DESIGN NOTE NO. 3

Subject: Detail of Riprap Above Berm on Earth Dam

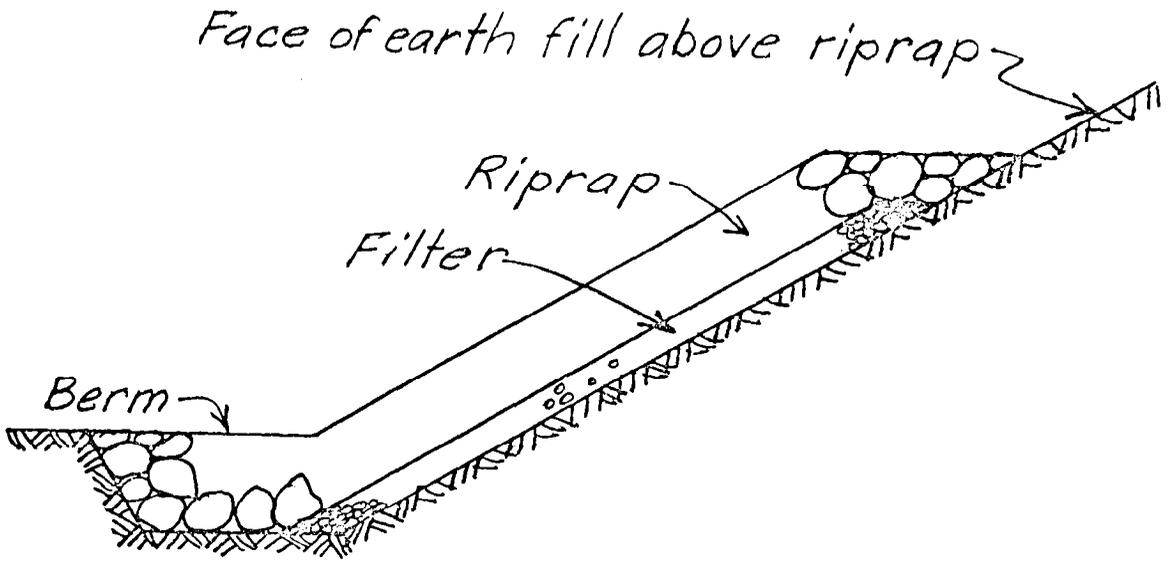
This matter was brought to our attention again at a recent meeting of the SCS-AGC Liaison Committee. The detail shown in view (a) is still being shown on some SCS drawings for relatively thin riprap blankets on earth dam slopes. Obviously, the detail requires that placement of earth fill be halted at the elevation at top of riprap until all of the filter and riprap have been placed. Detail (a) unjustifiably restricts the construction sequence since the detail shown in view (b) is equally functional and does not apply the same restriction.

It is strongly recommended that details for riprap generally conform to the layout illustrated in detail (b) and that all plans, regardless of the date of preparation, be revised if necessary to conform to this recommendation.
